City of Brisbane
Planning Commission Agenda Report

SUBJECT: **5000 Sierra Point Parkway;** Sign Review SR-7-16 to allow a new 7 sq ft, non-illuminated directional/parking sign to be installed within the parking lot of the DoubleTree Hotel; Preeti Sethi, SJP Signs, Inc., applicant; Summit Hospitality 114 LLC, owner; APN 007-163-030.

PROPOSED LOCATION

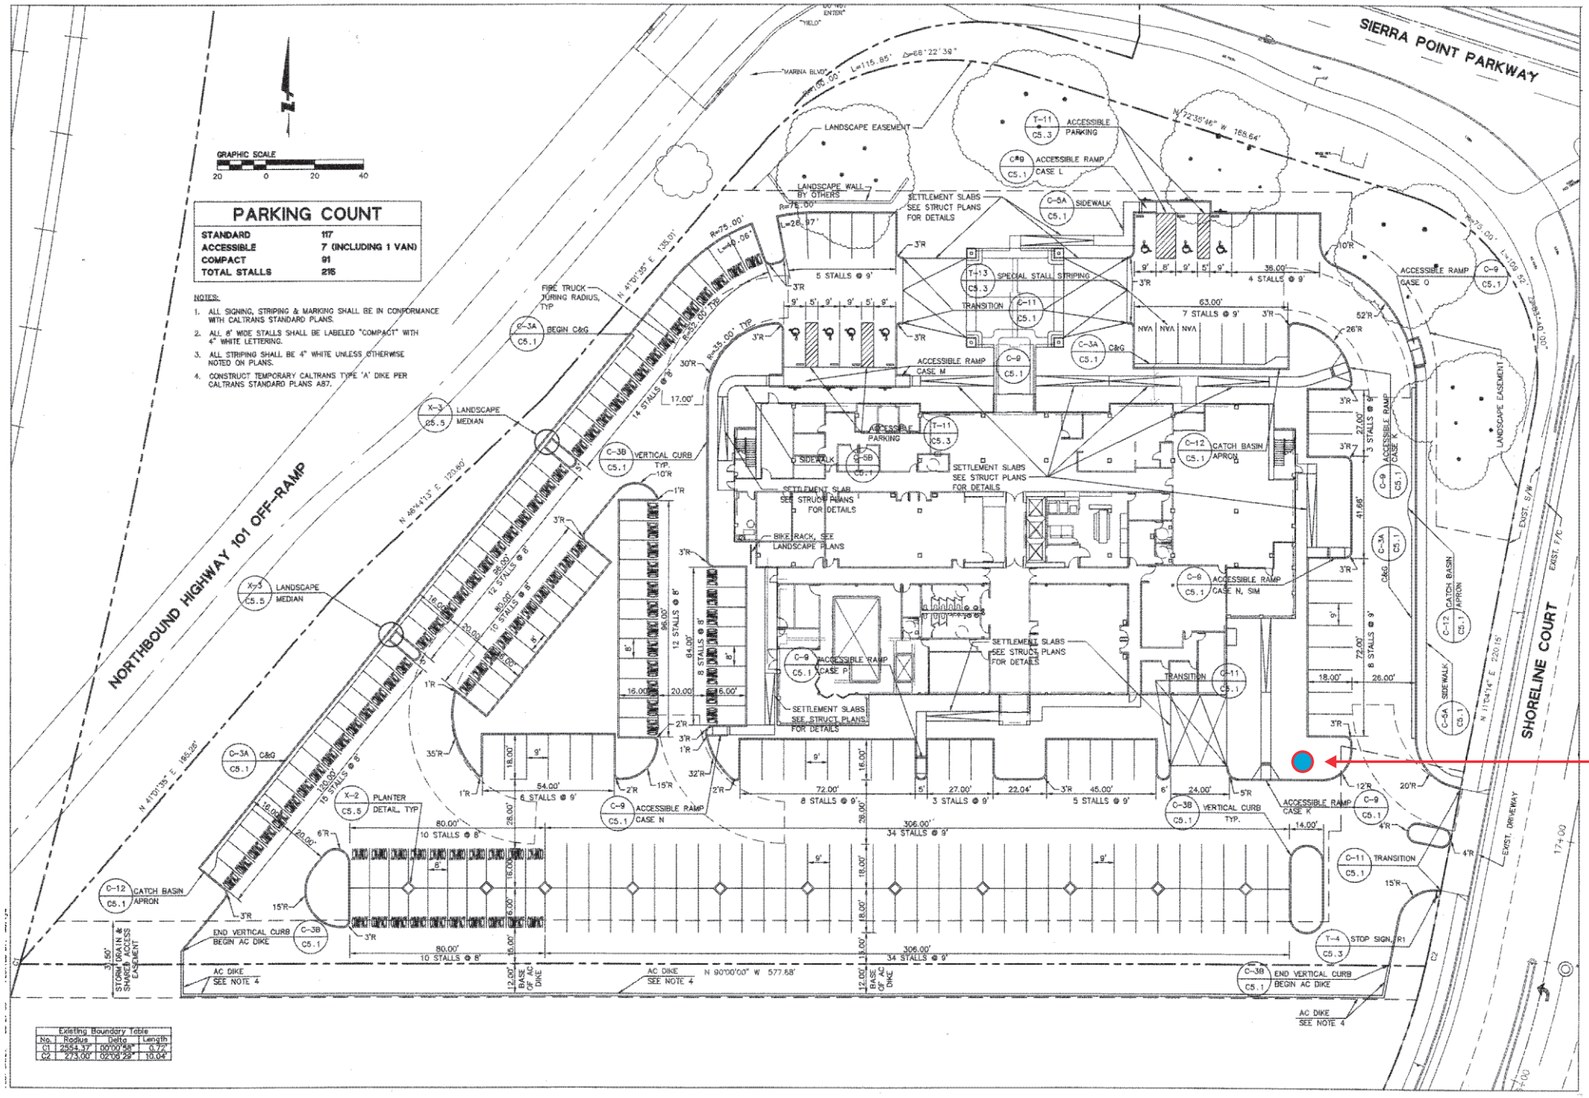
The sign would be located within a landscaped area in the hotel parking lot, primarily visible to cars entering the property from the Shoreline Court entrance to provide direction to various points of interest on the property, including the hotel lobby, parking, and the hotel restaurant.

NON ILLUMINATED DIRECTIONAL

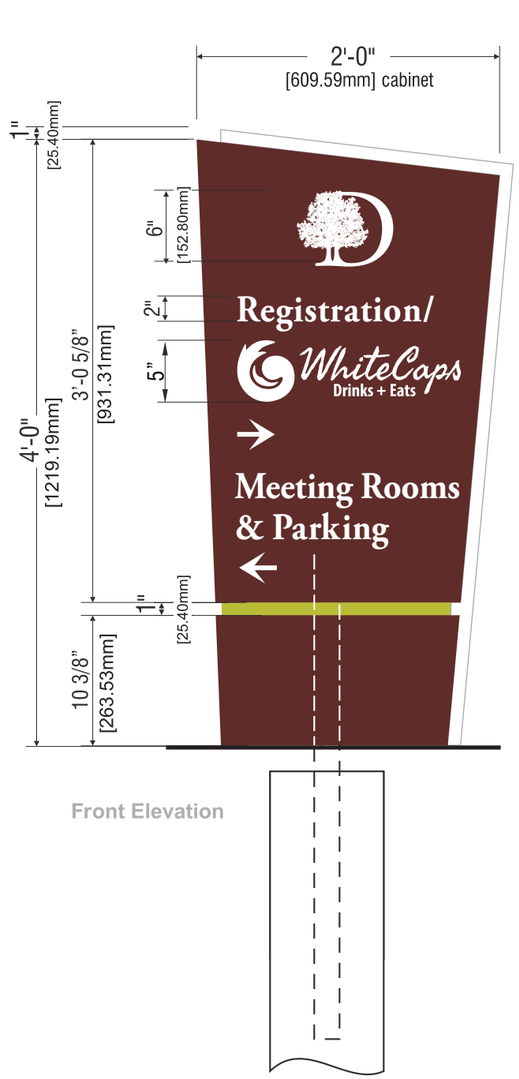
The application meets this finding. With the conditions of approval, the proposed directional/parking sign would comply with all applicable City ordinances. The asymmetrical blade sign would measure 4 ft (48 inches) at its tallest and 2 ft (24 inches) at its widest points. The sign width would not exceed 4 inches. Directional parking signs (Sign Type "E" in the Sierra Point Sign Program) are limited to a maximum of 46 inches tall, 16 inches wide, and 1 inch deep. Though moderately taller, wider, and deeper than the dimensions prescribed in the Sign Program, the overall scale of the sign would be consistent with "E" type signs which are subordinate to monument signage and other identification signs. Furthermore, the sign design is consistent and complementary to the signage program approved under SR-1-14 for the monument sign and wall-mounted signs.

As shown in the applicant's submittal, proposed sign materials include a brown aluminum base, green aluminum reveal, and brown aluminum face with white vinyl graphics (DoubleTree and White Caps logos) and text. These materials and sign colors complement those of the existing, approved monument sign located at the driveway entrance (SR-1-14) and are consistent with the hotel's branding.

A. A building permit application to install the directional sign is required. The plans submitted for the building permit shall substantially conform to the size, location, design, and materials indicated in the applicant's submittal (attached to the agenda report).

B. The sign shall not be illuminated.
